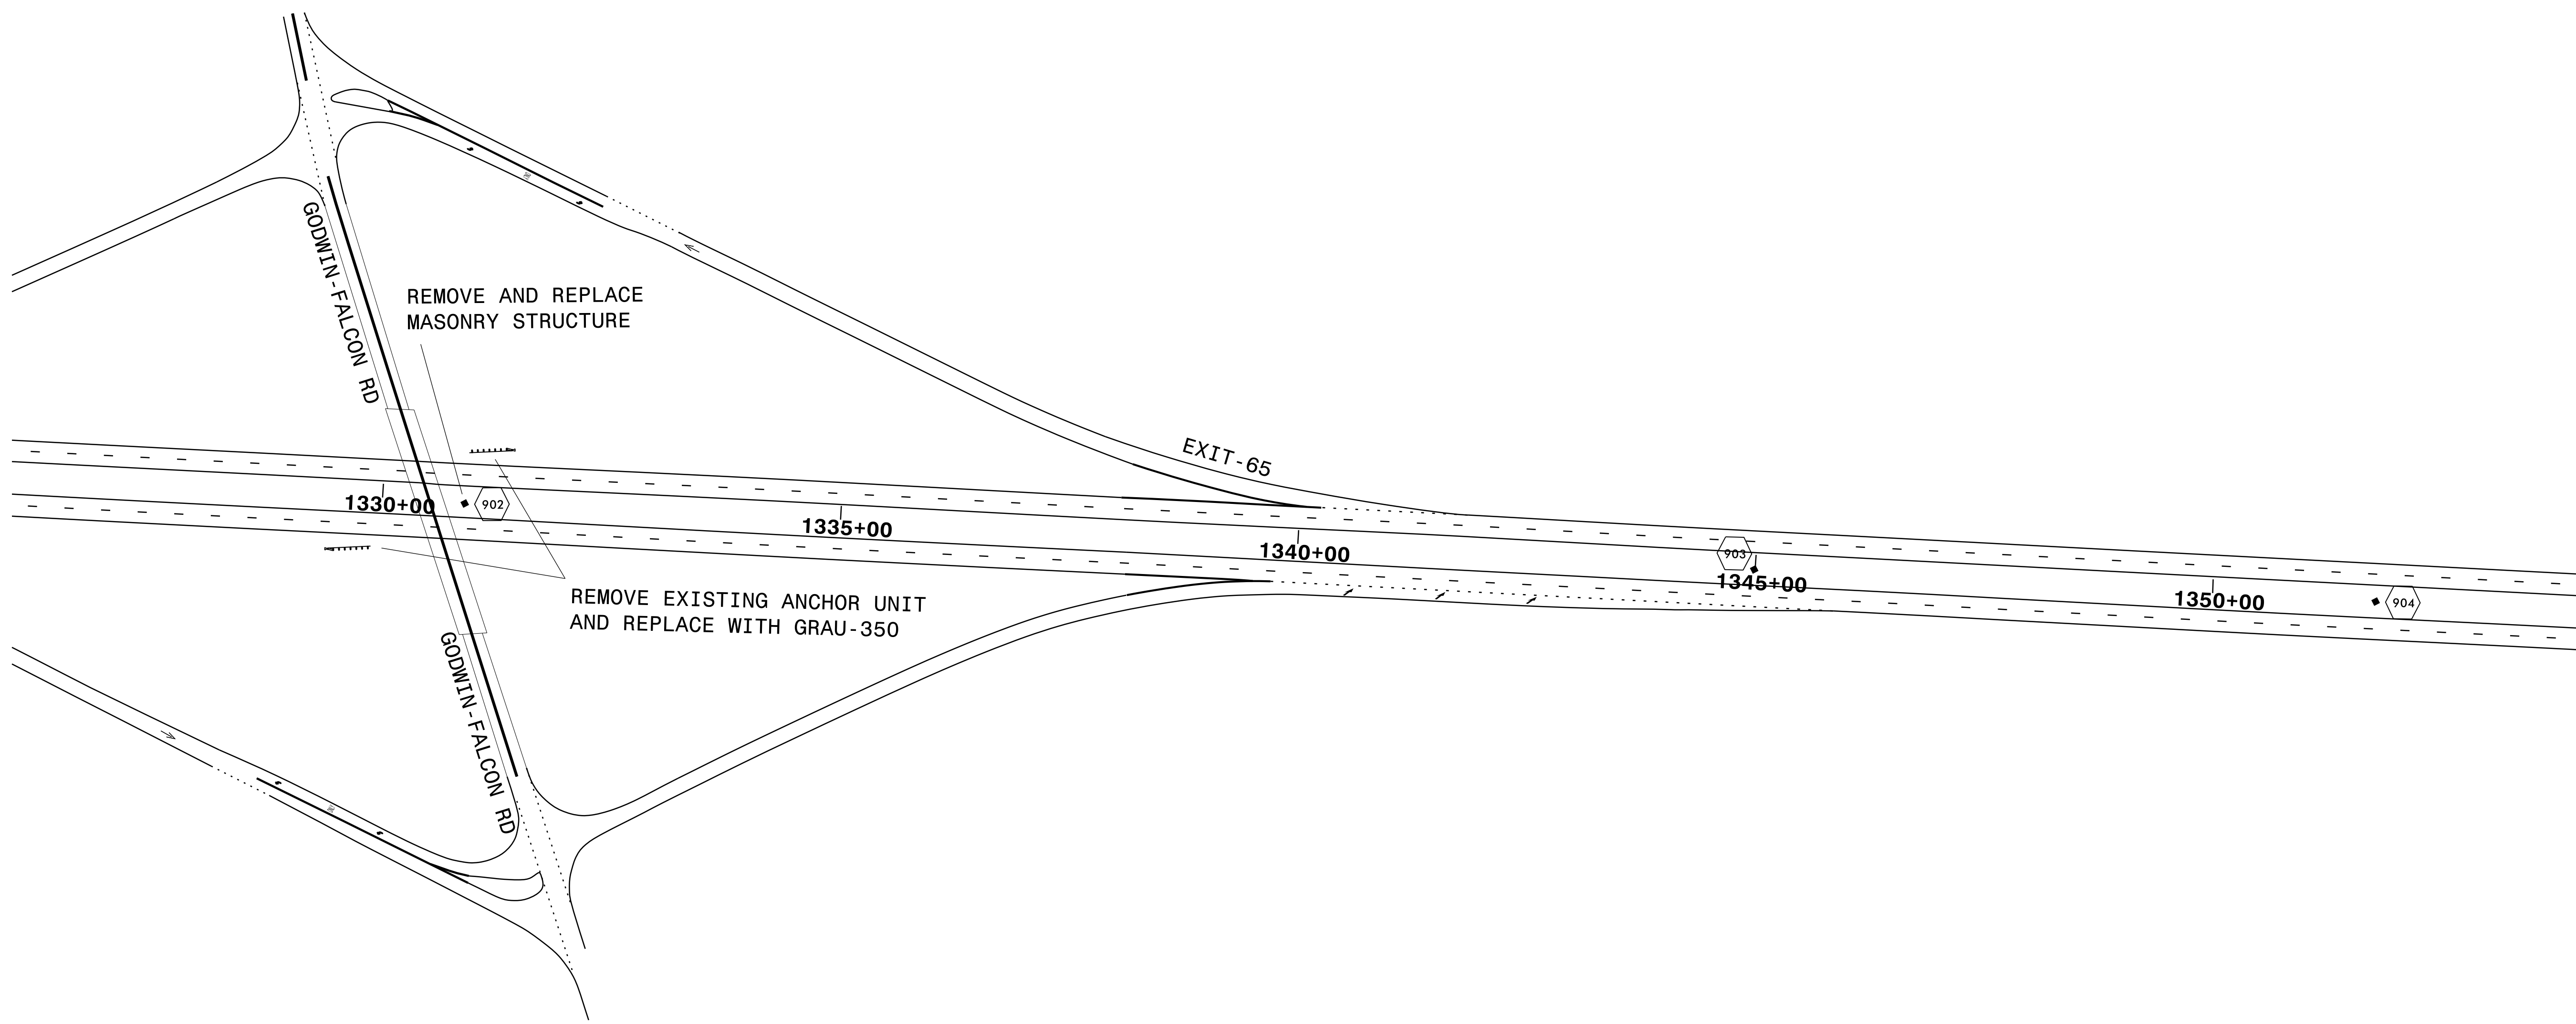
REMOVE EXISTING ANCHOR UNIT
AND REPLACE WITH GRAU-350

REMOVE AND REPLACE
MASONRY STRUCTURE

REMOVE EXISTING ANCHOR UNIT
AND REPLACE WITH GRAU-350
